Town of York Police Department

New Public Safety Building
& Access Road

Application for Final Site Plan Review

5th June 2014

SCALE: PROJECT MANAGER: DRL
 JC/DRAWN BY: WSM
 A/E OF RECORD: ADJ
 CAD FILE: C-124-06122
 PROJECT NO: 06122
 DATE: SHEET TITLE: WATER QUALITY PLAN
 SHEET No: C-124

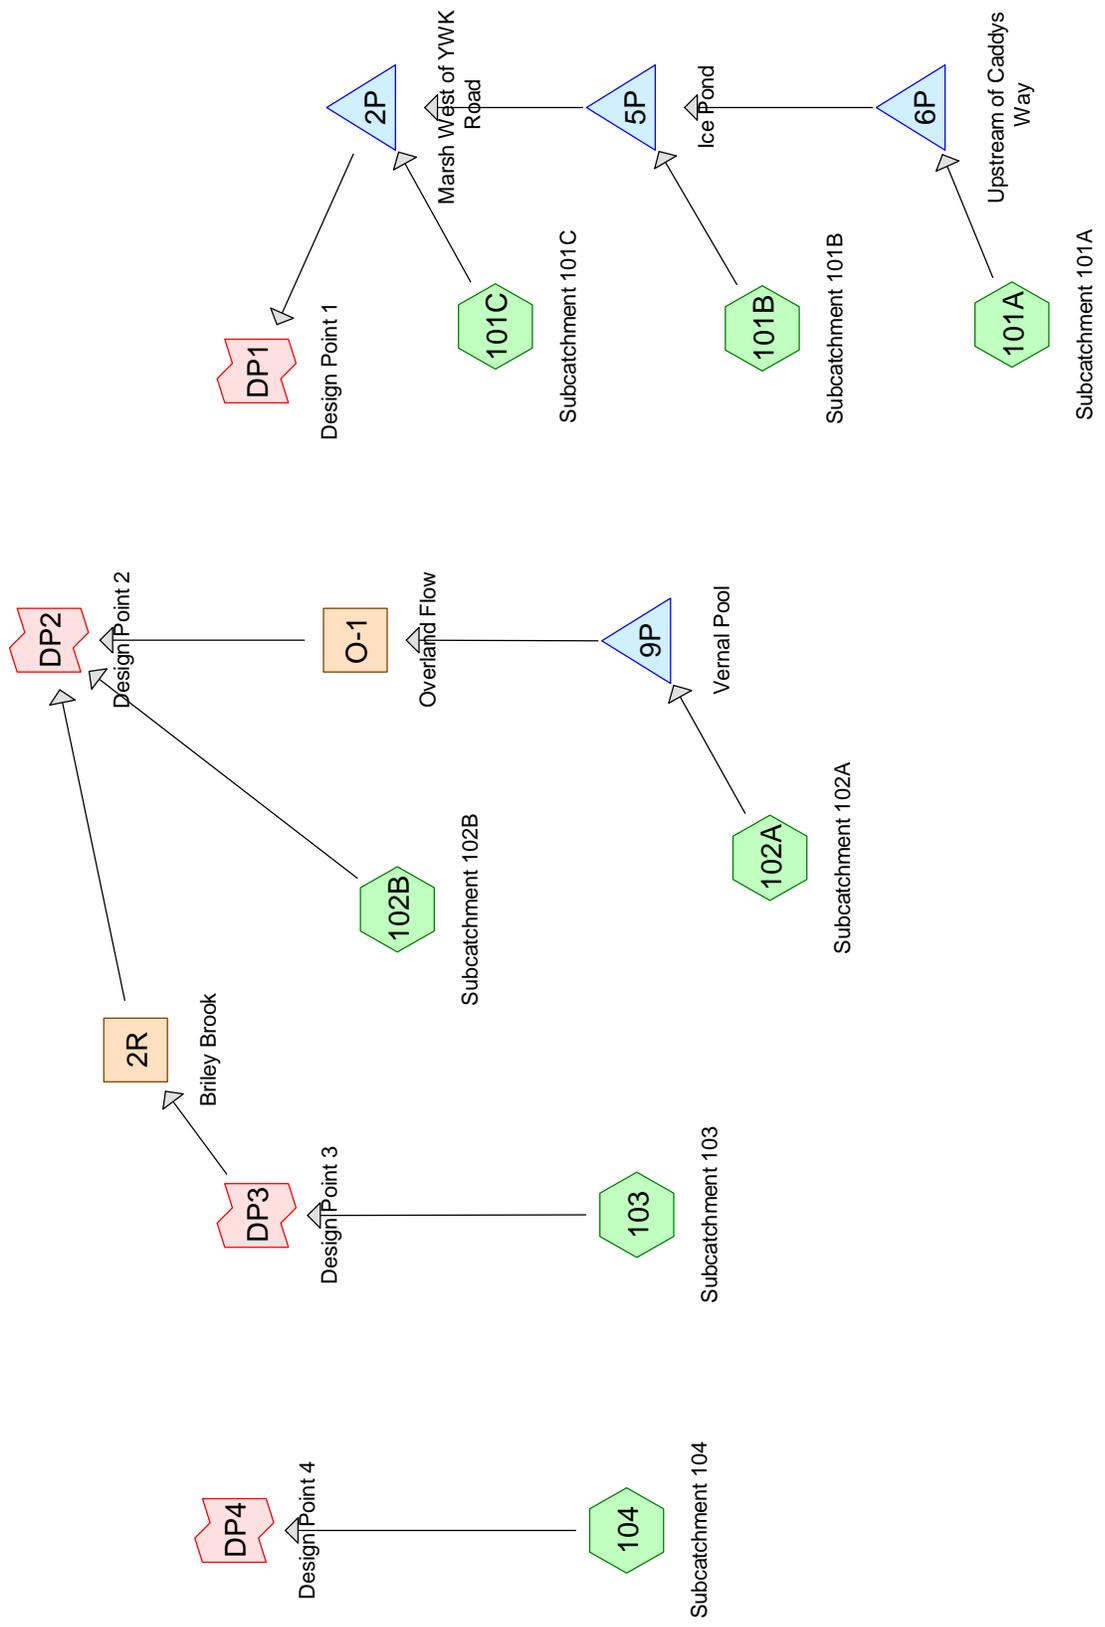
4. The water quality plan C124 does not match Sheet CG110
